SAFETY RECALL NOTICE

McLaren Voluntary Safety Recall Removal of Engine Floor Panel NVH Foam Padding (and Potential Fuel Tank Replacement)

Bulletin type:	Safety Recall Campaign
Reference number:	AFT.027.2020
Affected vehicles:	McLaren 570GT, McLaren GT, McLaren 720S (Coupe and Spider), McLaren Senna
Attention:	All Retailer Staff
Situation:	Voluntary Safety Recall - Potential for corrosion of the fuel tank
Procedure:	Action affected vehicles on next Retailer visit. Please refer to the information outlined in this document to remove the NVH foam padding on the engine floor panel and inspect the fuel tank for possible corrosion
Date:	2 nd July 2020

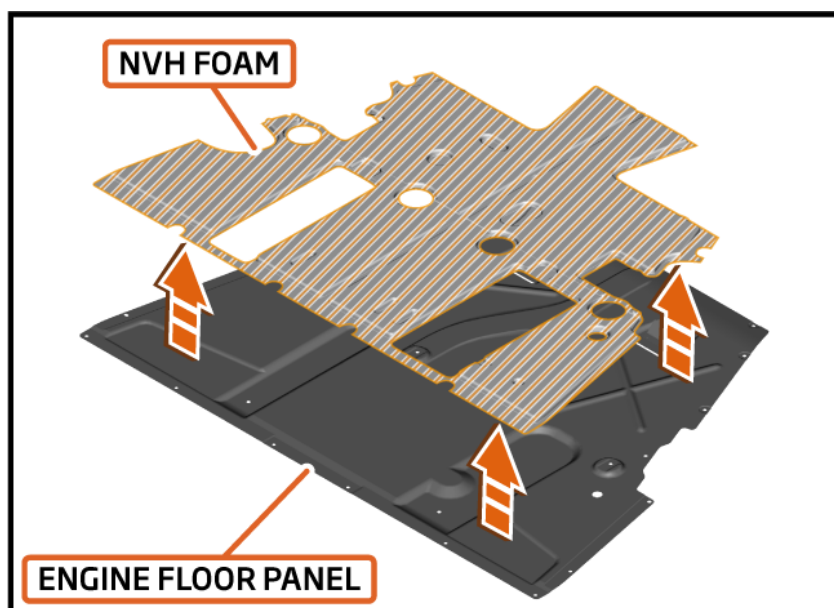
This voluntary recall relates to the fact that the Noise, Vibration and Harshness (NVH) foam padding positioned on the underside of the fuel tank can, in some instances, trap corrosive moisture, which can over time cause corrosion of the fuel tank. If not addressed, the corrosion may cause fuel vapour or liquid fuel to leak from the fuel tank, which could increase the risk of a fire.

1. Remove the engine floor panel
2. Inspect the fuel tank for signs of corrosion and / or leakage
 - a. If no signs of corrosion and / or leakage are found, continue to step 3
 - b. If signs of corrosion and / or leakage are found, please submit a Technical Request - Refer to section 4.2 below
3. Remove all the NVH foam padding on the engine floor panel
4. Clean off the residual adhesive which is left on the engine floor panel
5. Re-install the engine floor panel
